2019 INSPECTION REPORT Permit No. 17607 Dam ID No. IL 00545

SPRING LAKE DAM WINNEBAGO, COUNTY, ILLINOIS

Observed by: Arc Design Resources, Inc. 5291 Zenith Parkway Loves Park, IL 61111

Revision Date: November 27, 2019

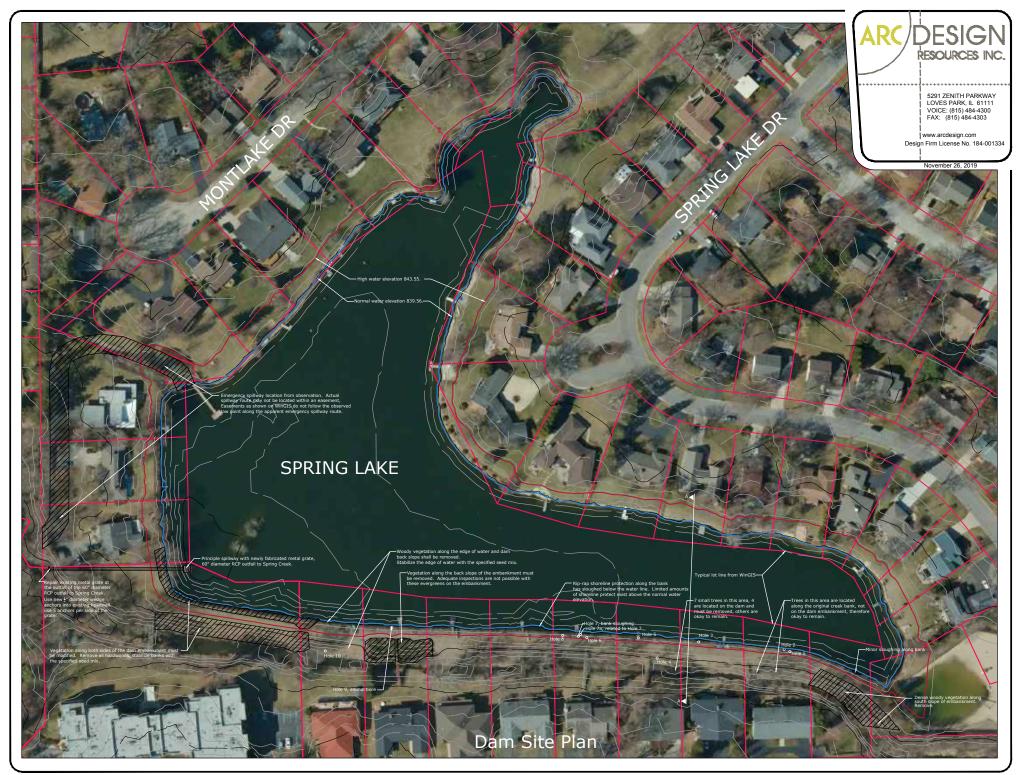
Item Description on Dam Site Plan	Detailed Description	Repair Recommendation
Minor sloughing along bank	Soil embankment slope has become steeper due to lack of stabilizing rip-rap	When lake level is down 2 feet, recompact weakened soil plane, add compacted clay, line with geotextile fabric, pull up sloughed rip rap along repaired slope to two feet above normal water level.
Hole 1	6" diameter hole in surface of dam face	Remove vegetation, fill with compacted clay, cap with 4" of topsoil, seed with specified seed mix.
Hole 2	6" diameter hole in surface of dam face at water level	Remove vegetation, fill with compacted clay, cap with 4" of topsoil, seed with specified seed mix.
Hole 3	3-4" diameter hole in surface of dam face	Remove vegetation, fill with compacted clay, cap with 4" of topsoil, seed with specified seed mix.
7 small trees in this area, four on the back slope of the dam must be removed	3 of the 7 trees in this area must be removed because they are on the back slope of the dam. The remaining trees are in the creek channel.	Remove tree, cut stump off level with ground surface, treat stump with herbicide.

Hole 4	3-4" diameter hole in surface of dam face, back slope	Remove vegetation, fill with compacted clay, cap with 4" of topsoil, seed with specified seed mix.
Hole 5	3-4" diameter hole in surface of dam face	Remove vegetation, fill with compacted clay, cap with 4" of topsoil, seed with specified seed mix.
Hole 6	3-4" diameter hole in surface of dam face	Remove vegetation, fill with compacted clay, cap with 4" of topsoil, seed with specified seed mix.
Hole 7	4' x 3' slough in surface of dam face upslope from rip- rap	Remove dislodged soil and vegetation, fill with compacted clay, cap with 4" of topsoil, seed with specified seed mix.
Hole 7a - related to adjacent slough	2' x 2' slough in surface of dam face upslope from rip- rap	Remove dislodged soil and vegetation, fill with compacted clay, cap with 4" of topsoil, seed with specified seed mix.
Hole 8	minor slough in surface of dam face	Removed dislodged soil, remove vegetation, fill with compacted clay, cap with 4" of topsoil, seed with specified seed mix.

Vegetation along the back slope of the embankment must be removed	Evergreen plants on both sides of elevated walkway to dam	Remove plant material and roots. Replace disturbed soil with compacted clay, cover with 4" of topsoil, apply specified seed mix.
Hole 9, animal bore	2" diameter hole in surface of dam face	Remove vegetation, fill with compacted clay, cap with 4" of topsoil, seed with specified seed mix.
Hole 10	3-4" diameter hole in back slope surface of dam face	Remove vegetation, fill with compacted clay, cap with 4" of topsoil, seed with specified seed mix.
Vegetation along both sides of the dam embankment must be modified	Excessive plant growth on dam embankment is not acceptable.	Remove woody plant material and roots. Replace disturbed soil with compacted clay, cover with 4" of topsoil, apply specified seed mix.
Principle spillway with newly fabricated metal grate.	Principle spillway, top grate, 60" dia pipe outfall.	Lake drawdown valve must be modified to be operational from top of new metal grate. A manually operated gate valve is recommend with an extended valve shaft and operating wheel.

Emergency spillway location from observation.	The emergency spillway appears to be set at the appropriate grade and will function as originally designed. WinGIS does not show the overland flood route easements as shown on the original construction plans.	Consider replatting a portion of the property to correctly show the overland flood route in a properly sized drainage easement. Priority is low.
